Access Compliance Report Public Rights-of-Way (Curb Ramps)

Main Street: W BALL RD Cross Street: S BROOKHURST ST Location: SE

ADA ID: RPAT211129092542 Ramp Type: Type 1 - Perpendicular Diagonal Initial Pass/Fail: Pass Overall Compliance: No Severity Score: 2

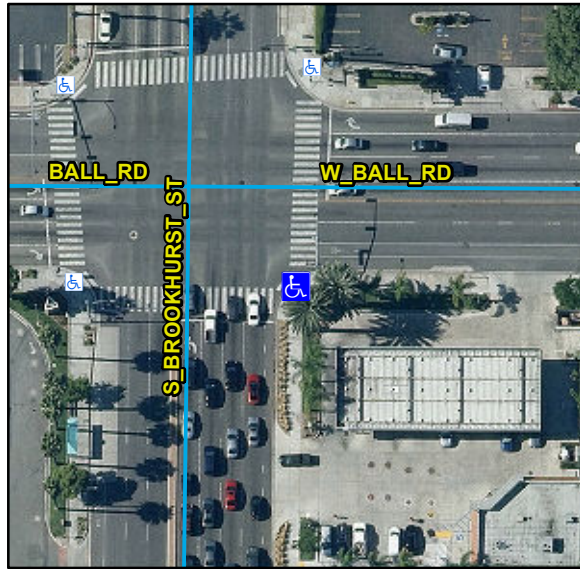
R304.2.1, R304.5.3, STD 1115

Remove & Replace Landing.
